PLANNER'S REPORT

RE: Design Review - 3365 Northside Drive

The City of Hapeville has received a design review application from Paula Smith to construct a 1.5 story single-family dwelling with an attached garage at 3365 Northside Drive. The dwelling will have 3,548 SF of finished heated floor area with an additional 525 SF of unfinished space available. It will include four bedrooms and three and a half bathrooms, with an optional unfinished fifth bedroom.

SITE PLAN

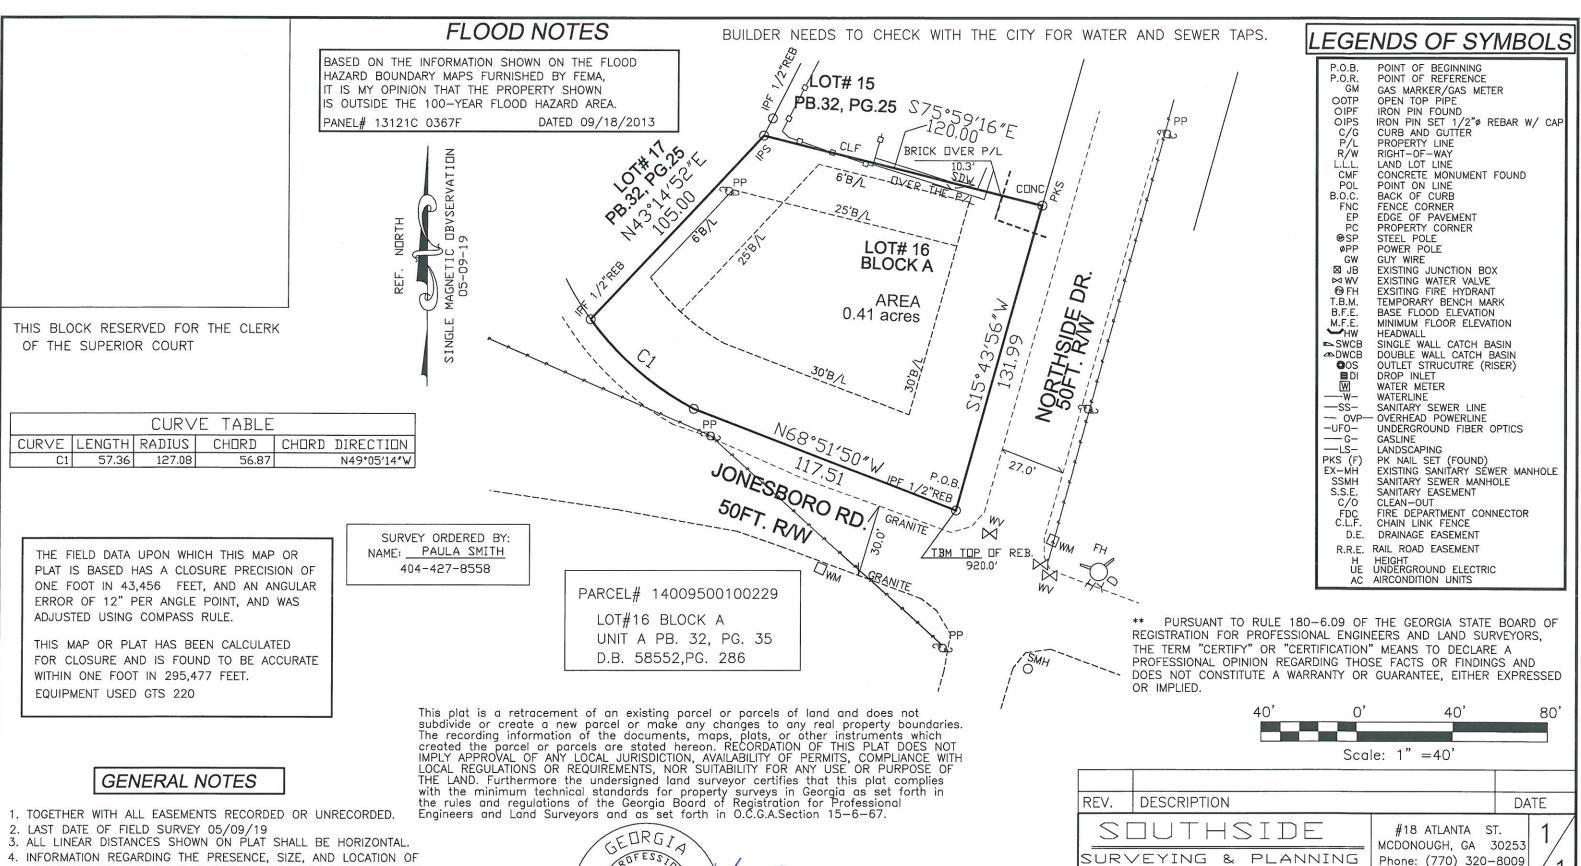
STAFF COMMENT: The plans should include a new sidewalk on each enfronting street, with a minimum 1' landscape zone and 4' clear zone.

A minimum of one tree is required every 50' in the supplemental area. The application should be revised to ensure at least one tree is located every 50' along both Northside Drive and Old Jonesboro Road frontages.

The Applicant should clarify how the mechanical features on the west side of the dwelling will be screened.

STAFF COMMENT: The driveway is 15' wide at the curb but expands towards the garage, which is not compliant.

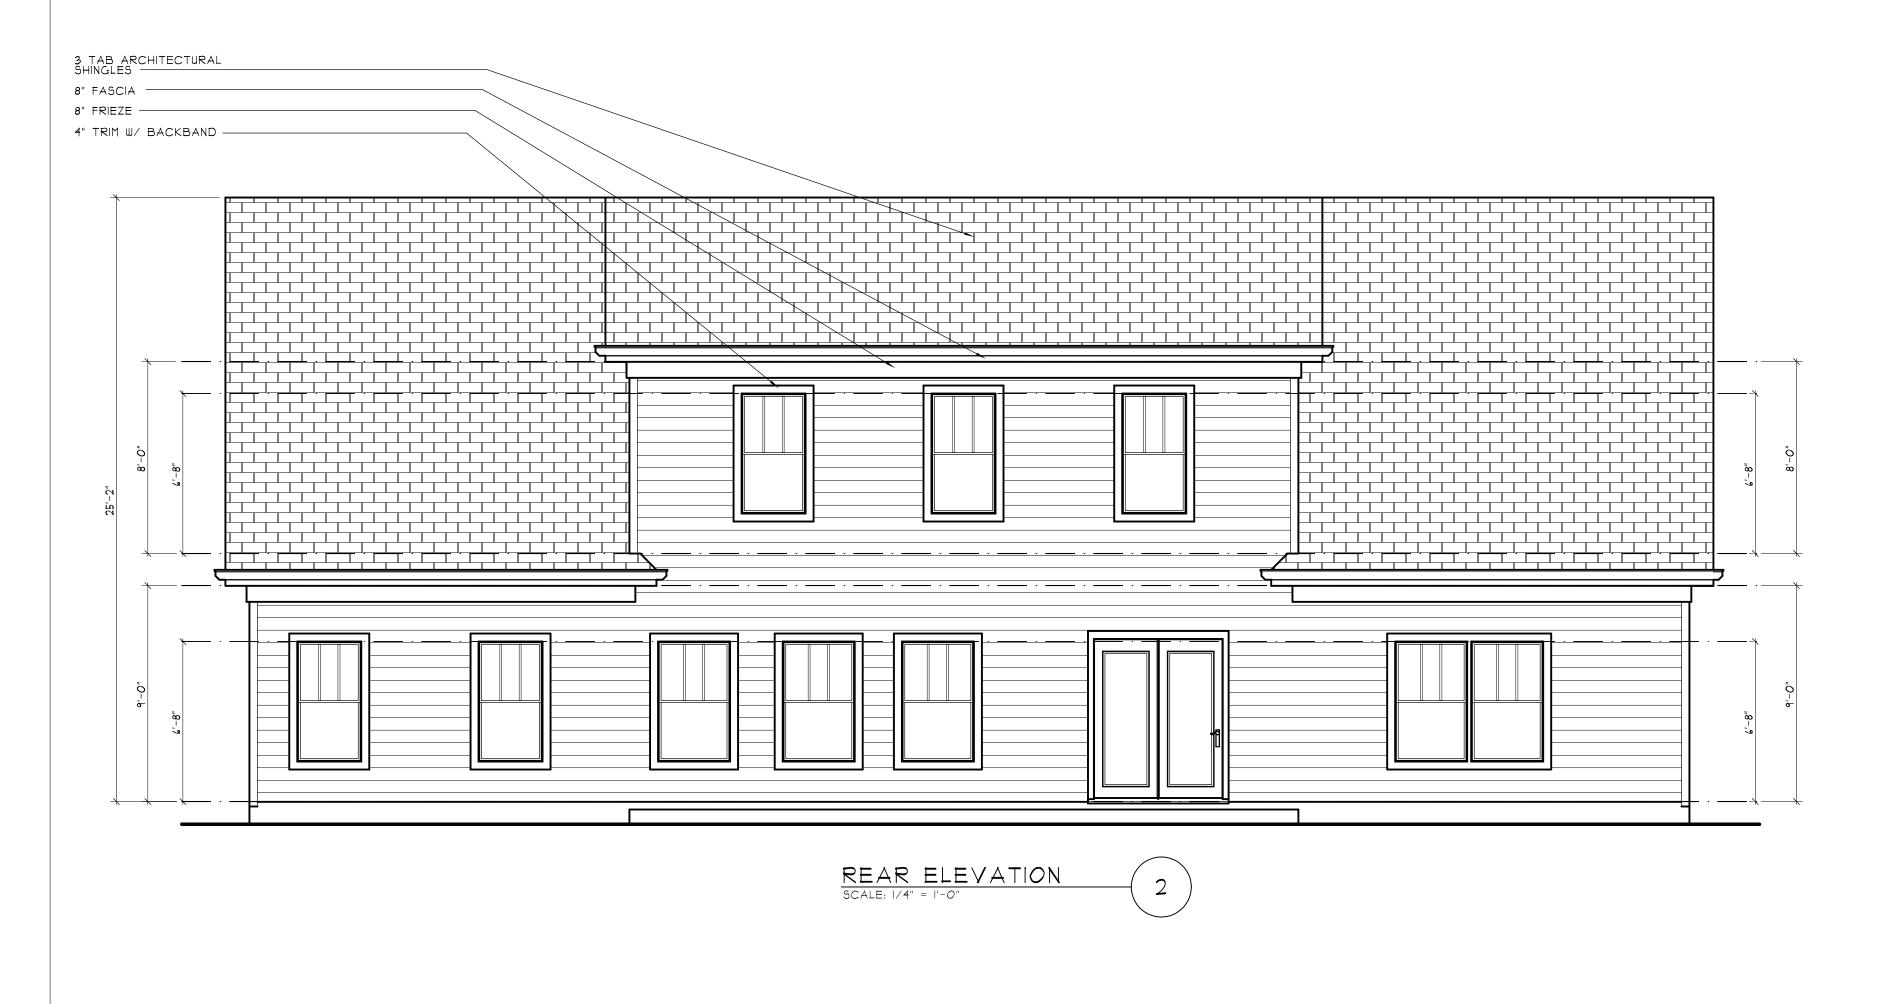
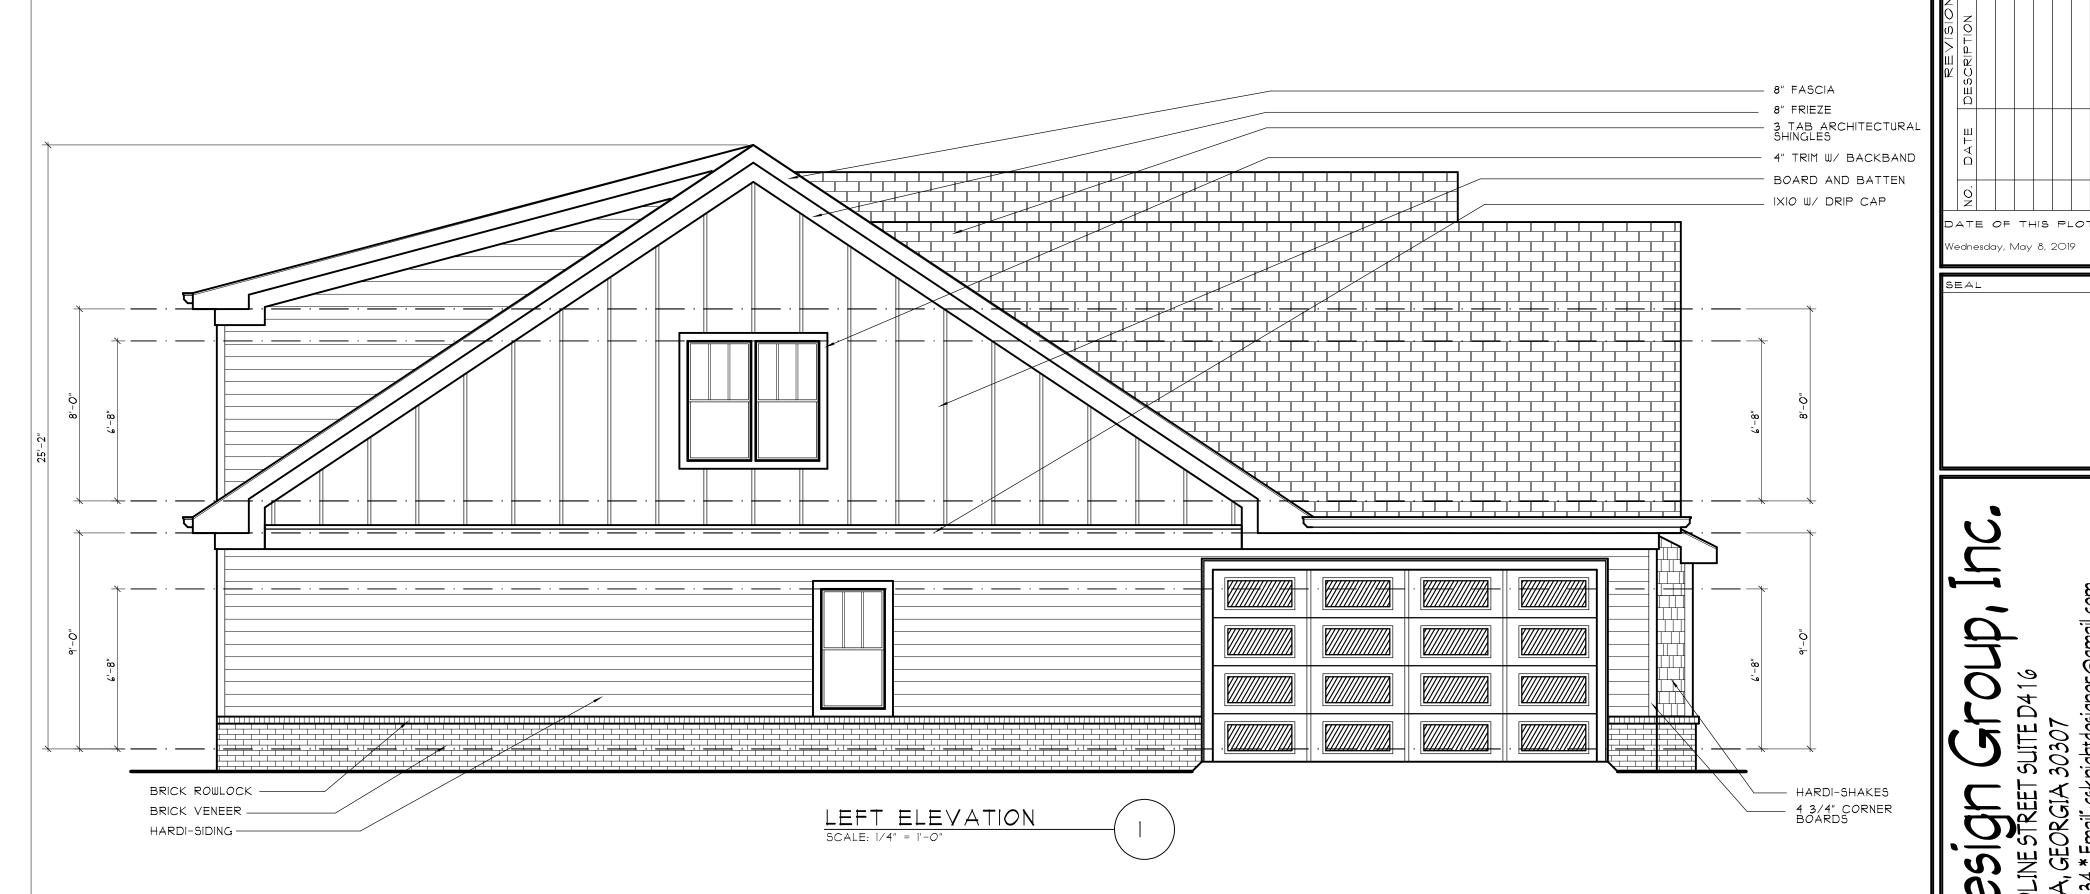
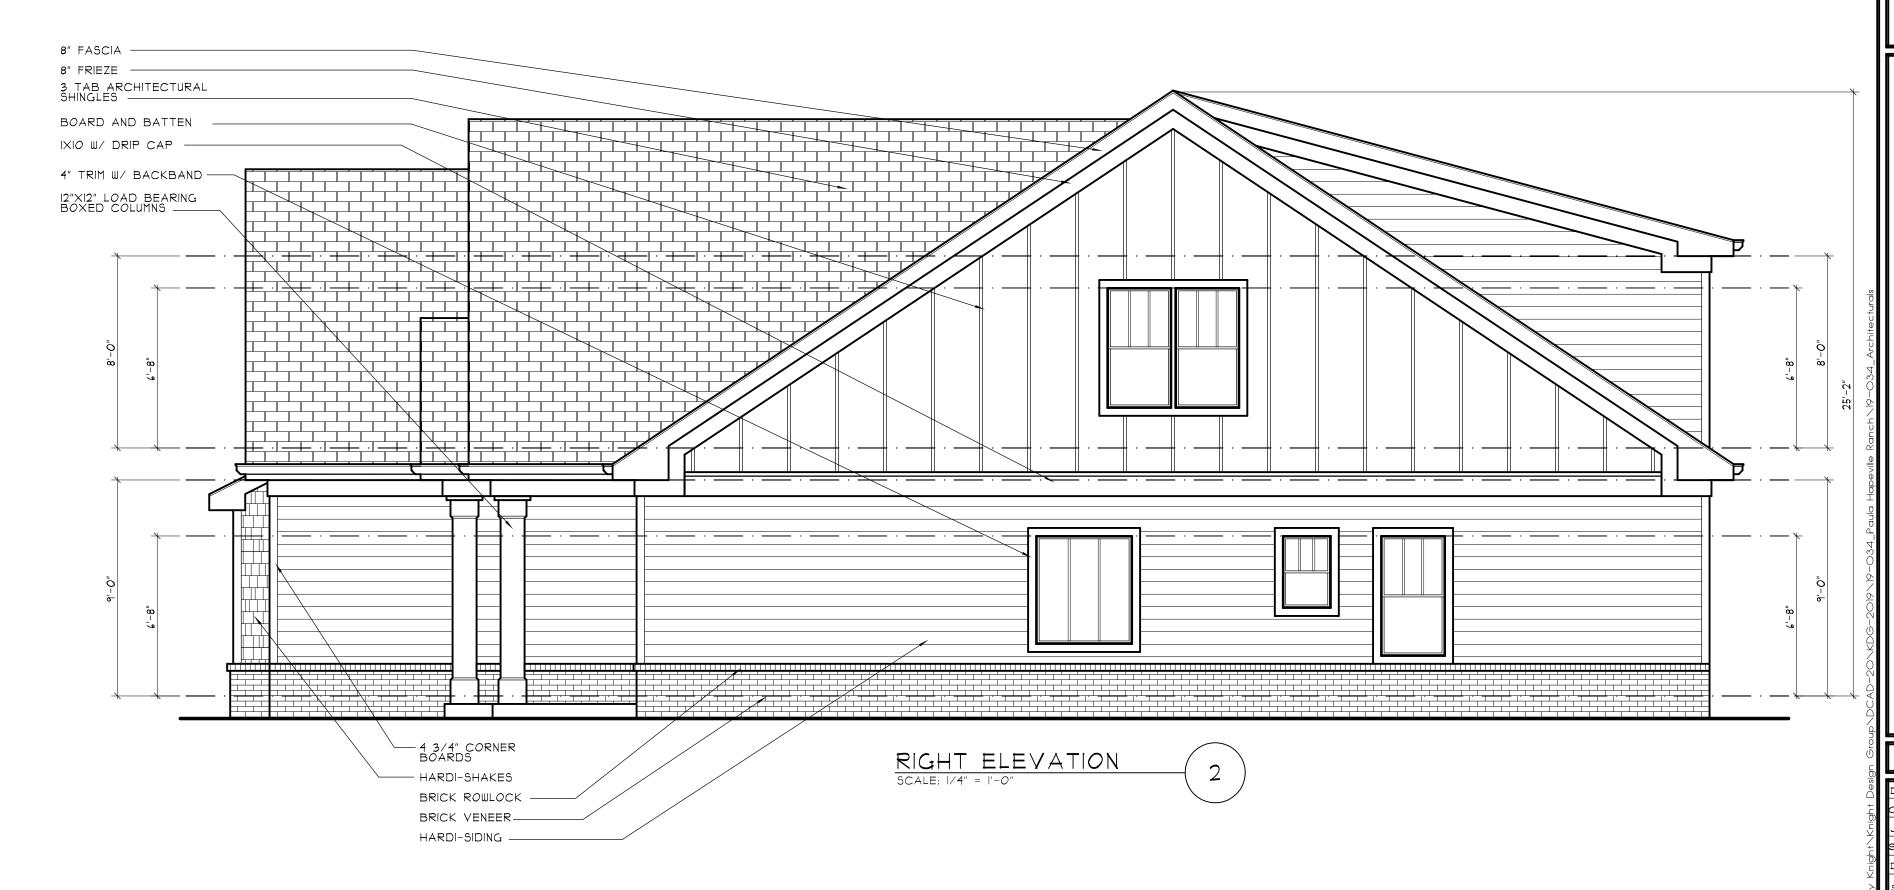
The Applicant should ensure the roof shingles have a warranty of at least 30 years and indicate the warranty on the plans. The Applicant should indicate the material of the gutters and downspouts and show downspouts on the plans.

The minimum clear depth between the front façade and the outside of the porch columns is 8'. The clear depth is 6' at its narrowest, which is not compliant.

Front porch widths must be between 80% and 100% of the adjacent façade. The porch is 70% of the façade, which is not compliant.

The Applicant should provide the spacing between porch columns, ensuring they are spaced no more than 8' on center.

Windows must enfront for between 30% and 50% of the Old Jonesboro Road facing façade.
